Figure 16. Simulated rockfall after 100 years of thermal loading and one episode of dynamic ground motion for two slightly different fracture patterns

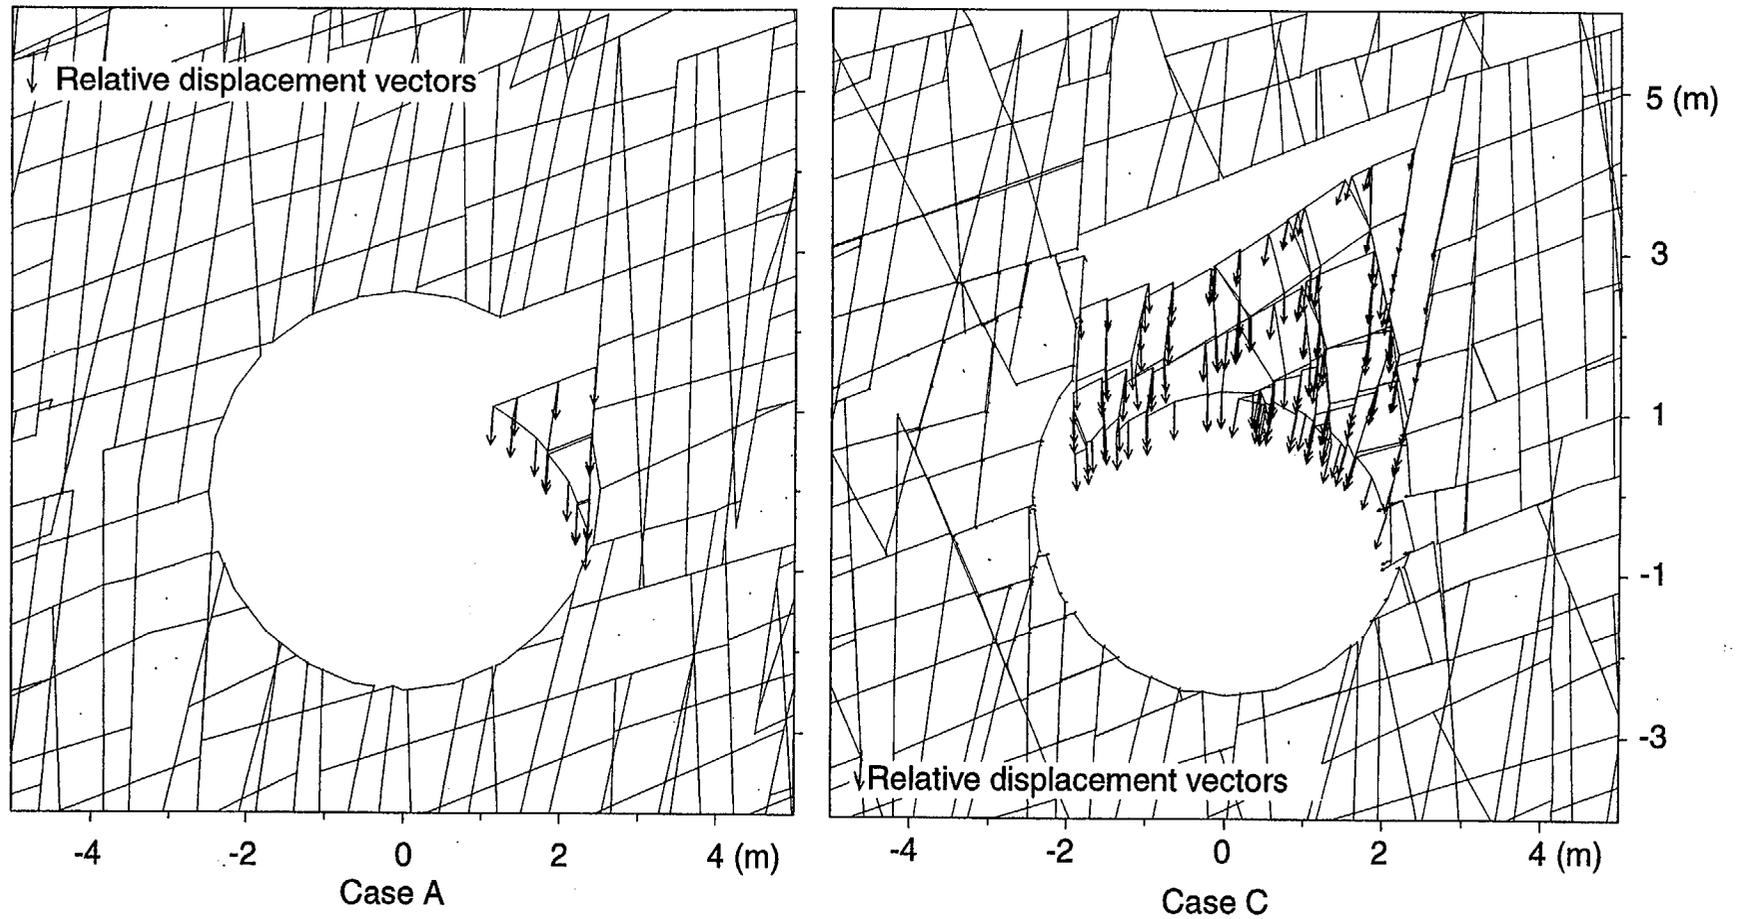
It is DOE's decision to design the ground supports to maintain stability of the emplacement drifts for the preclosure period only, therefore, the continuing function of the ground supports beyond permanent closure cannot be assured. Consequently, the underground openings must be assumed to be unsupported during the postclosure period. Postclosure response within the underground facility will be controlled by thermal stresses imposed on a rock mass that may be experiencing progressive degradation of strength and elastic properties caused by sustained loading and extended exposure to heat and moisture. The expected behavior around unsupported underground openings under such conditions includes collapse of the surrounding rock into the openings and consequent cave-in of the roof area, leading to changes in geometry (size and shape) of the openings and changes in

hydrological properties (such as fracture porosity and permeability) in the vicinity of the openings (see Figure 16).

Figure 20. Department of Energy integrated safety analysis methodology

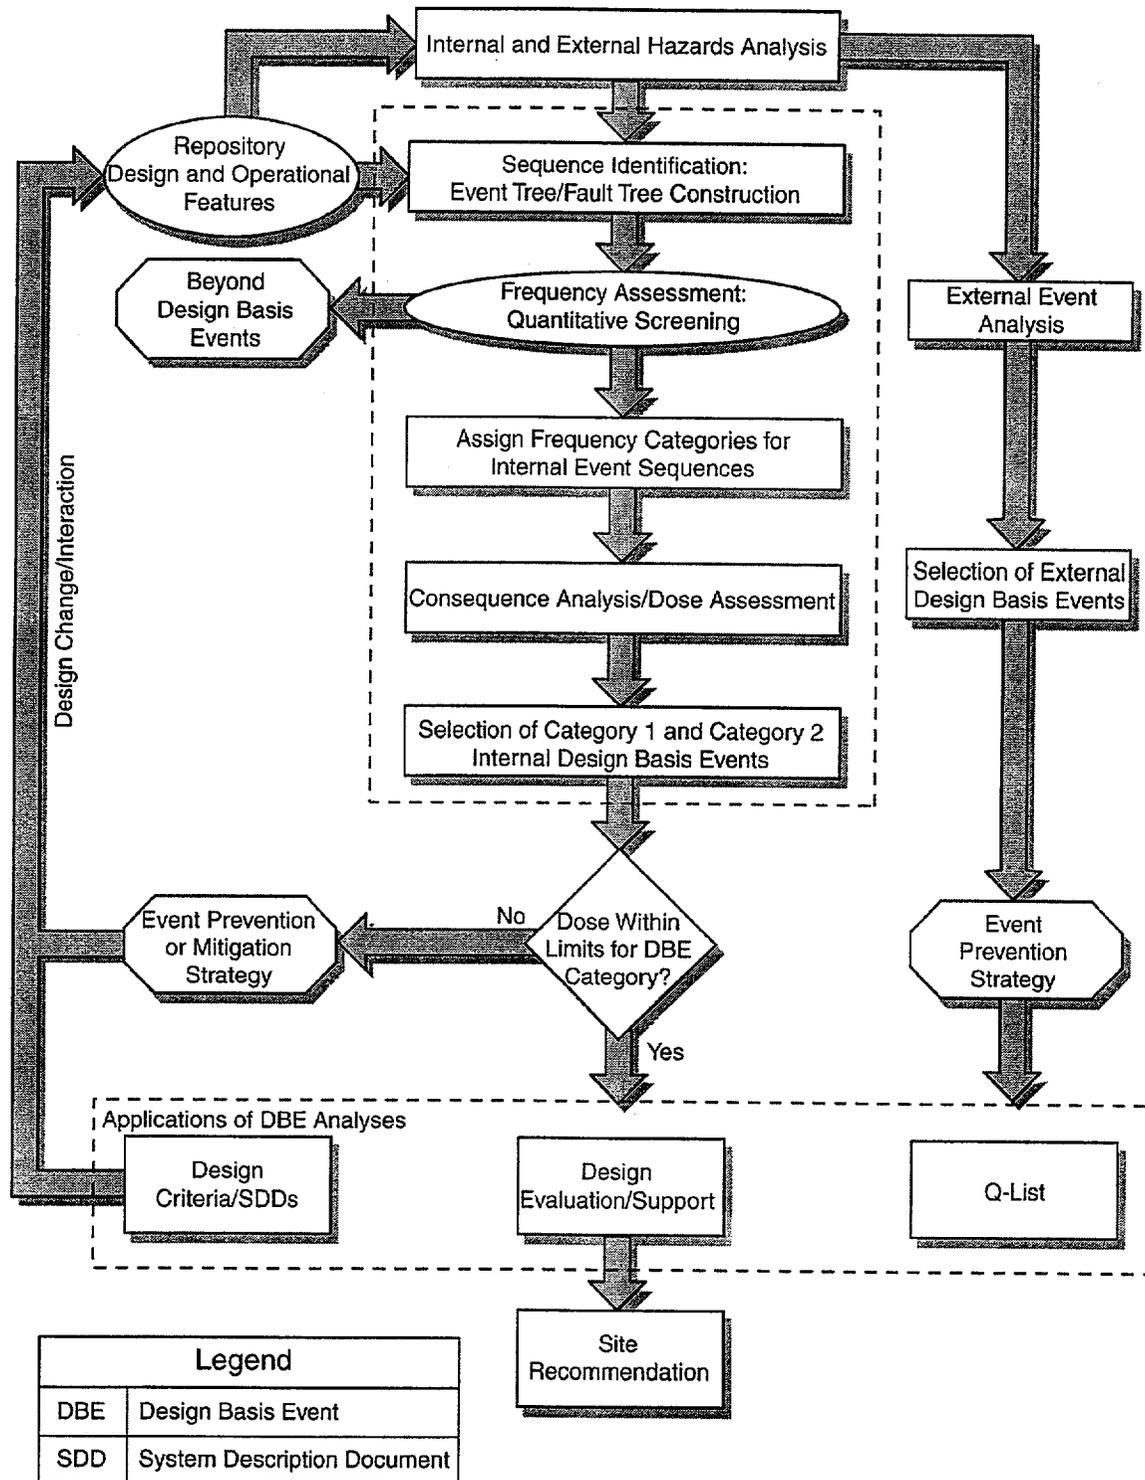
The DOE's methodology for ISA is schematically represented in Figure 20. The chart explains the process of implementation of ISA to meet the preclosure safety objectives through internal and external hazard analyses. The objective is to identify the DBE from internal (human-induced and equipment failures) and external (manmade and natural phenomena) events for consideration in the design of the GROA and identification and classification of the SSCs that are important to safety.
